Subject: Letter of Opposition — Proposed Fill and Drainage Plan

Figure 1: 9-8ft of fill proposed. Stake is roughly where retaining wall is depicted on the drawing submitted. Picture is from the perspective of looking down Webster Street.

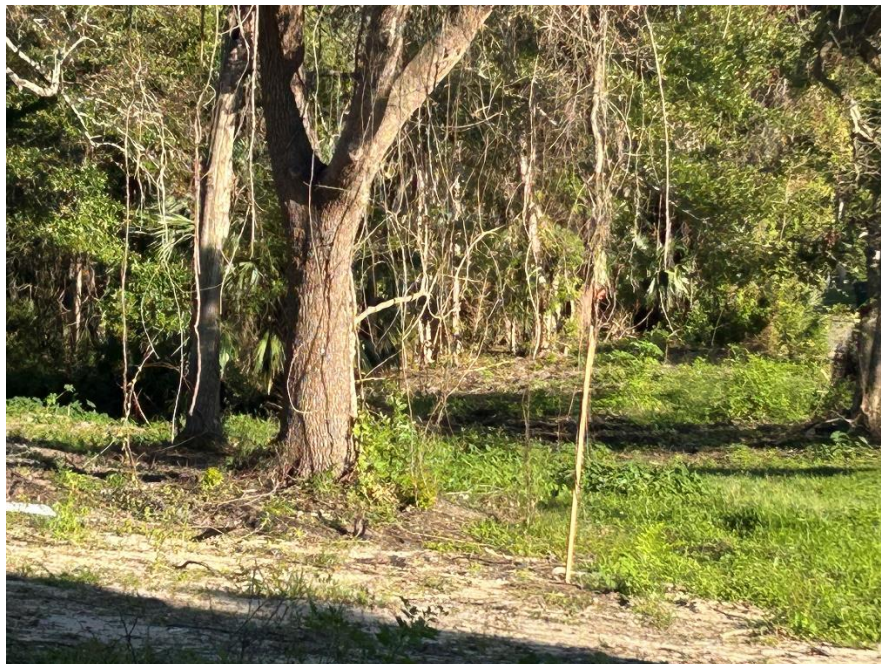
Photographs and field stakes show proposed fill in the range of **8–9 ft**. The retaining wall is located roughly 6–10 ft from the old oak tree shown in the photos. These changes represent a substantial encroachment into the floodplain.

Given the proposed volume of fill and the location within a floodway swale, this project appears to violate the ordinance and should not be permitted.

Figure 4: July 2, 2026 map showing current buildable areas, existing drainage flow, and proposed drainage concerns. Green Shaded Area – Buildable Area. Green Arrows – current drainage flow. Orange areas of concern – erosion and pooling.

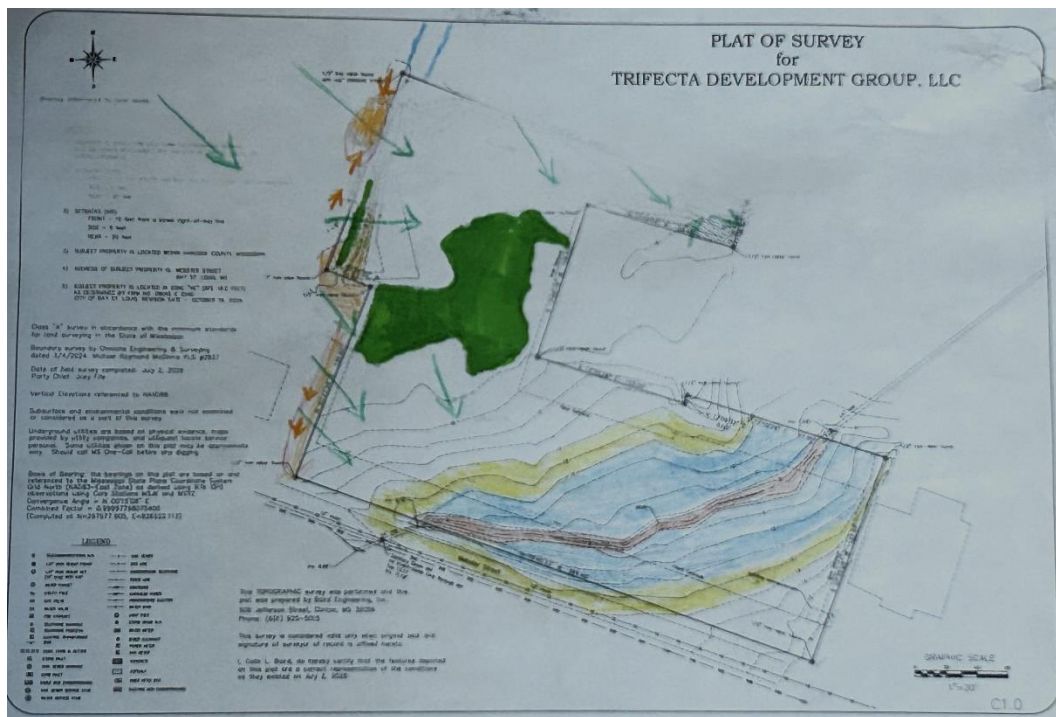
- **Green shaded areas** on the plat indicate portions above 18 ft (BFE) and considered buildable.
- **Green arrows** show existing drainage flow across the property. After the July 4 land disturbance, the property's topography changed: the rear of the lot has become a pit, and the area above 18 ft has been reduced by roughly half.
- **Orange areas** indicate locations of erosion and pooling and show where flow changes could affect adjacent properties. Two water staking locations are noted along the protruding top-left corner of the site.

The back-left corner of the development contains a **2–3 ft depression** adjacent to an old oak tree. This depression is a likely collection point for runoff and sediment.

Figure 6: Erosion Control indicated in Packet submitted by Trifecta.

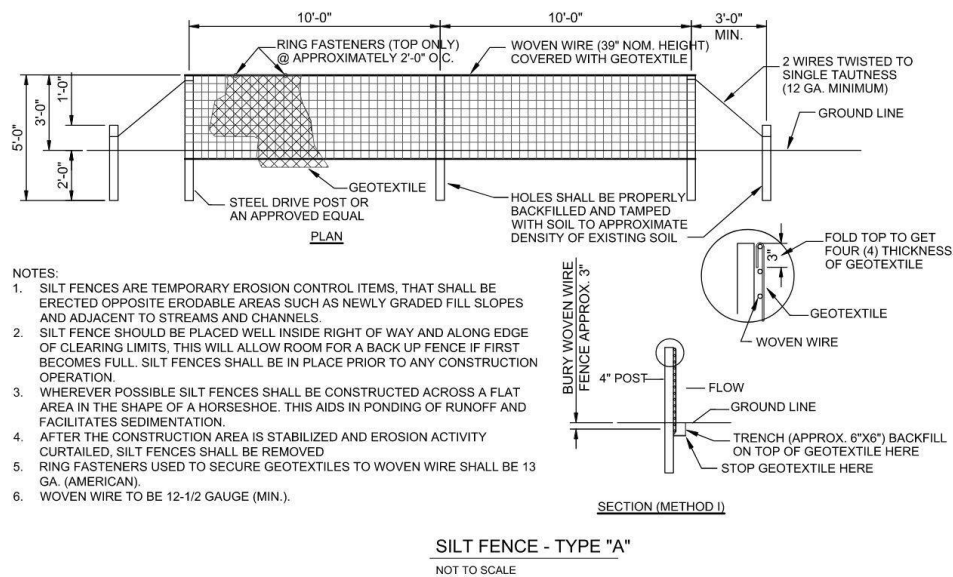
The submitted plans indicate erosion and sediment control measures are required, but no current measures are in place. The city has spent grant funds and staff time cleaning sediment and debris from stormwater systems in this area. The developer's prior work—disturbing land without permits and failing to implement erosion controls—reduces confidence that the project will be properly managed.
